PIC24FJ256GB110 Family Silicon Errata and Data Sheet Clarification

The PIC24FJ256GB110 family devices that you have received conform functionally to the current Device Data Sheet (DS39897C), except for the anomalies described in this document.

The following typographic corrections and clarifications are to be noted for the latest version of the device data sheet (DS39897C):

FIGURE 2-3 FREQUENCY vs. ESR PERFORMANCE FOR SUGGESTED VCAP

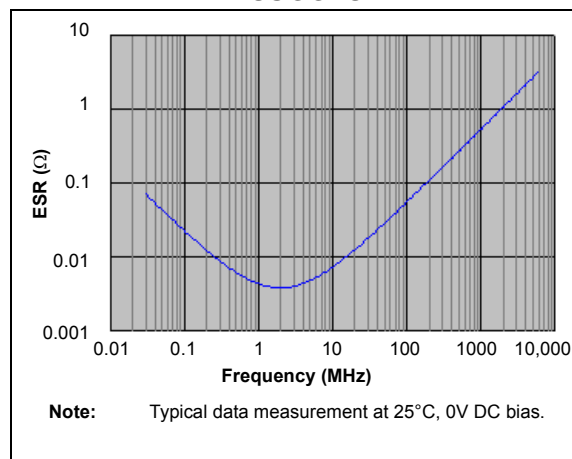
Section 2.4 Voltage Regulator Pins (ENVREG/DISVREG and VCAP/VDDCORE) has been replaced with a new and more detailed section. The entire text follows:

When the regulator is enabled, a low-ESR ($< 5\Omega$) capacitor is required on the VCAP/VDDCORE pin to stabilize the voltage regulator output voltage. The VCAP/VDDCORE pin must not be connected to VDD and must use a capacitor of $10\ \mu\text{F}$ connected to ground. The type can be ceramic or tantalum. Suitable examples of capacitors are shown in [Table 2-1](#). Capacitors with equivalent specifications can be used.

Designers may use [Figure 2-3](#) to evaluate ESR equivalence of candidate devices.

FIGURE 2-4 DC BIAS VOLTAGE vs. CAPACITANCE CHARACTERISTICS

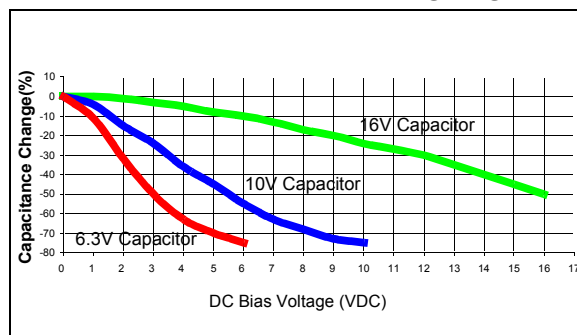
In addition to temperature tolerance, the effective capacitance of large value ceramic capacitors can vary substantially, based on the amount of DC voltage applied to the capacitor. This effect can be very significant, but is often overlooked or is not always documented.

A typical DC bias voltage vs. capacitance graph for 16V, 10V and 6.3V rated capacitors is shown in Figure 2-4.

When selecting a ceramic capacitor to be used with the internal voltage regulator, it is suggested to select a high-voltage rating, so that the operating voltage is a small percentage of the maximum rated capacitor voltage. For example, choose a ceramic capacitor rated at 16V for the 2.5V core voltage. Suggested capacitors are shown in Table 2-1.

FIGURE 29-1: PIC24FJ256GB110 FAMILY VOLTAGE-FREQUENCY GRAPH (INDUSTRIAL)

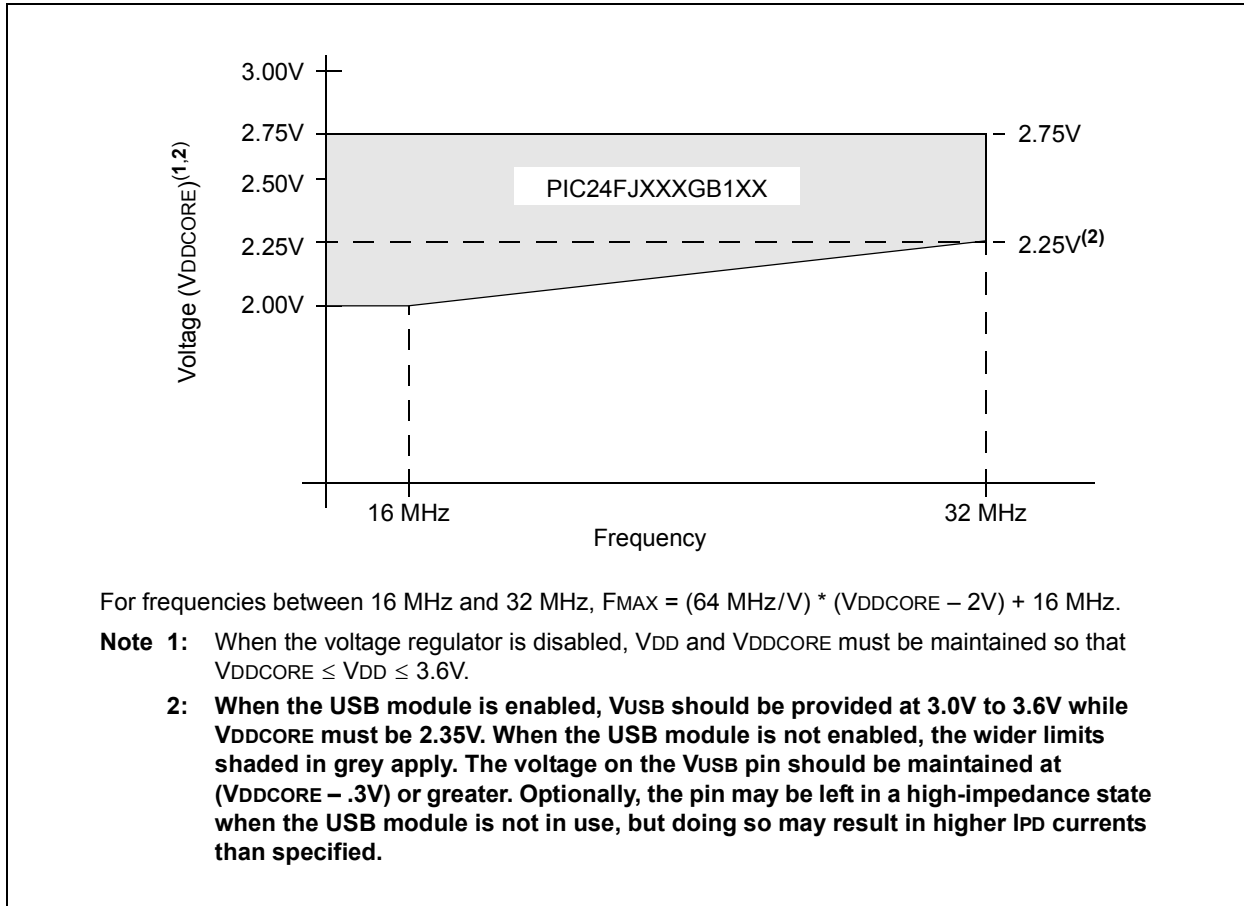
Figure 29-1 (“PIC24FJ256GB110 Family Voltage-Frequency Graph”) is amended by adding an additional footnote. The updated figure is shown below (changes in **bold**; bold in original removed for clarity).
